Tesla, Inc. Service Bulletin		<i>Replace Flood Port Plungers</i>	
SB-25-16-002 May 5, 2025					
Classification		Section/Group	Mobile Service	Configuration	
Campaign Bulletin		16 - HV Battery	Cannot Perform	All	
Model	Model Year	Country/Region	Build Location		
Model S	2021–2022	United States, Europe	Fremont		
Model X	2021–2022				
The model(s) and model year(s) listed are a general approximation of the affected VIN list. Refer to the VIN/Bulletin Tracker or Customer/Vehicle profile to determine applicability of this bulletin for a particular vehicle.

On certain Model S and Model X vehicles built between approximately January 2021 and September 22, 2022, the High Voltage (HV) battery ports' plungers intended for internal water leak egress (also known as flood ports) can be replaced with plungers that are more robust against external ingress due to submersion during flooding or other similar high-severity abuse instances.

Figure 1

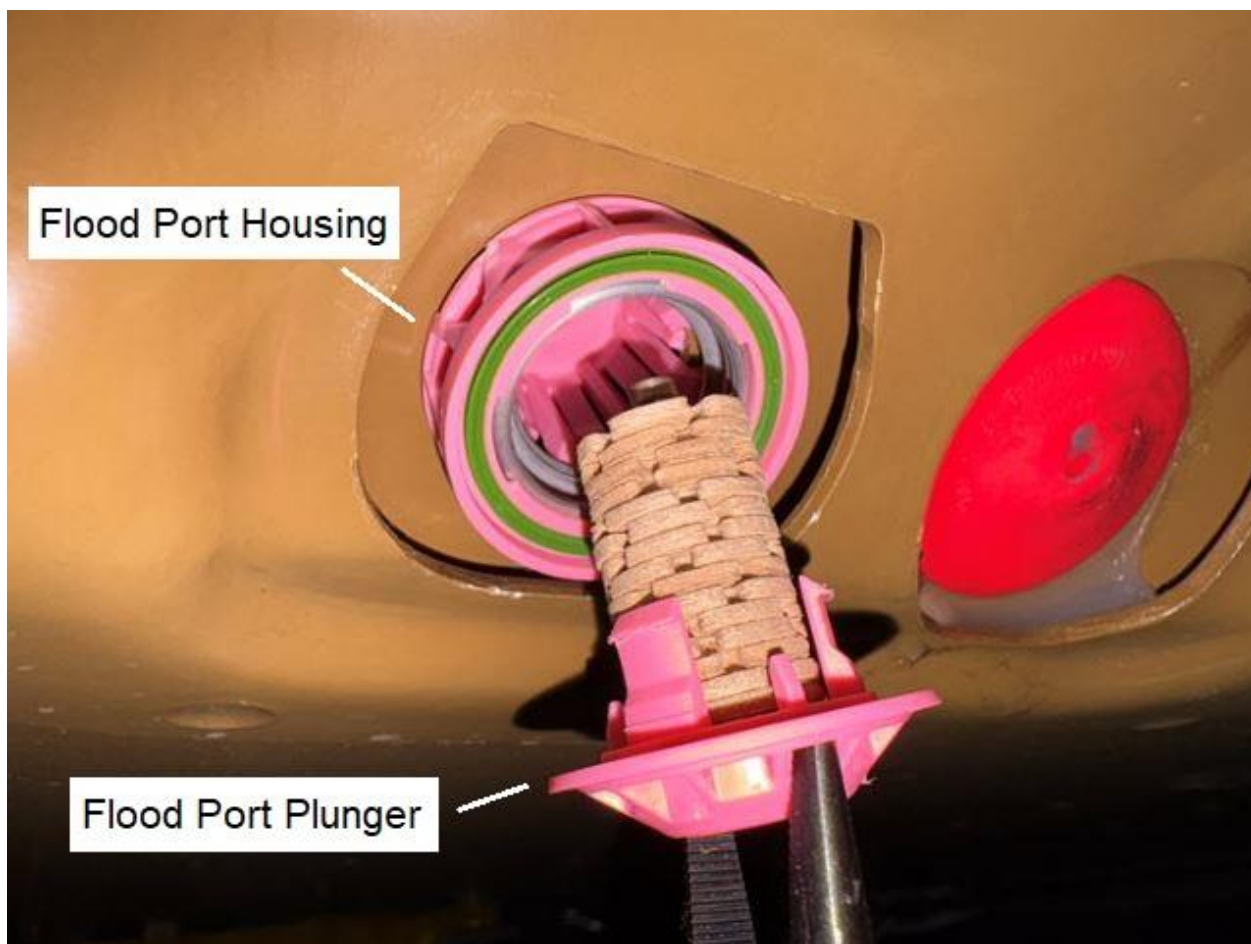
⚠ CAUTION: The Service Manual procedure only replaces the flood port plunger (Figure 1). **Do not** replace the flood port housing.

Replace the flood port plungers (x5) (refer to Service Manual procedure 16102712; [Model S](#), [Model X](#)).
